**Official Transcript of Proceedings**  
**NUCLEAR REGULATORY COMMISSION**

Title:                   Advisory Committee on Reactor Safeguards  
                                  Open Session

Date:                    Thursday, November 3, 2016

638TH MEETING

“White paper” – ML111030586

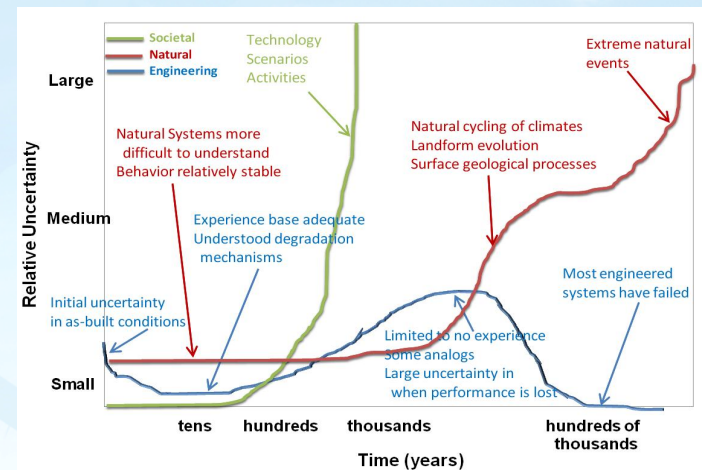
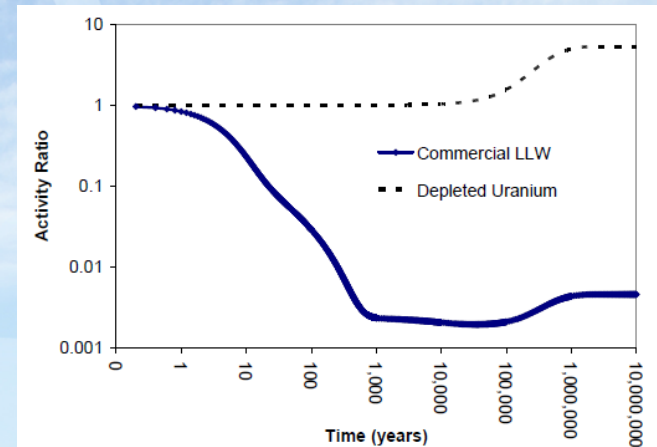
11 MEMBER REMPE: I was curious about this  
12 white paper, which I appreciated getting a copy of.  
13 But like this composites on the lower right was I  
14 guess a composite based on the earlier Figure 3,  
15 which had no axis on the different plots.

16 But it said the staff used their  
17 experience with waste disposal systems to generate  
18 Figure 3, which I guess was the basis for Figure 4.  
19 Some of the information in both of those figures is  
20 pretty precise.
